Original Plan

#1 Original Proposal - Rejected

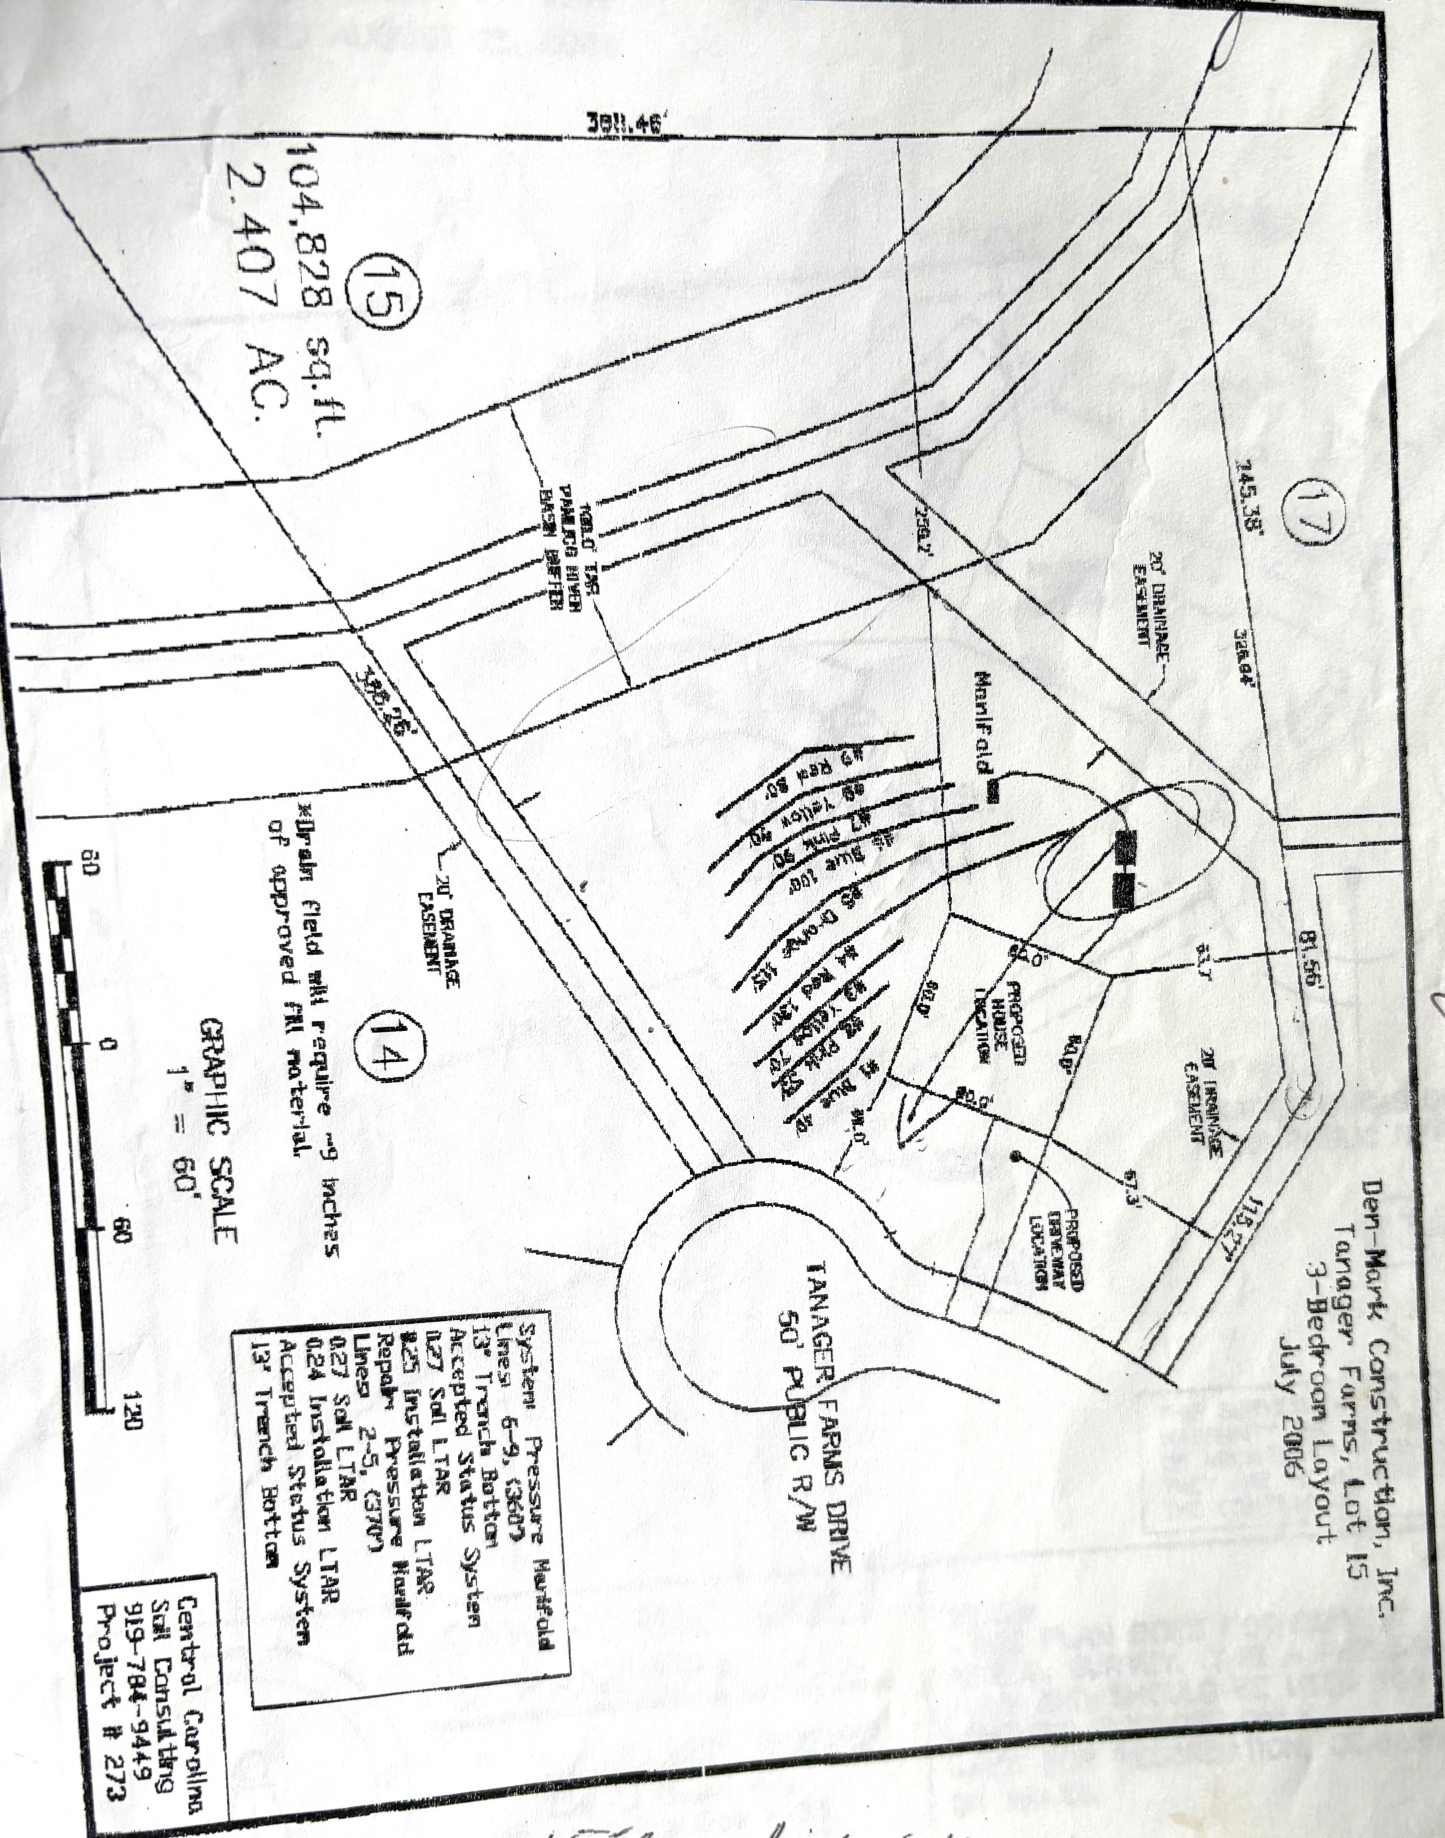
15' from pool to septic
10' feet to septic - for old steel.
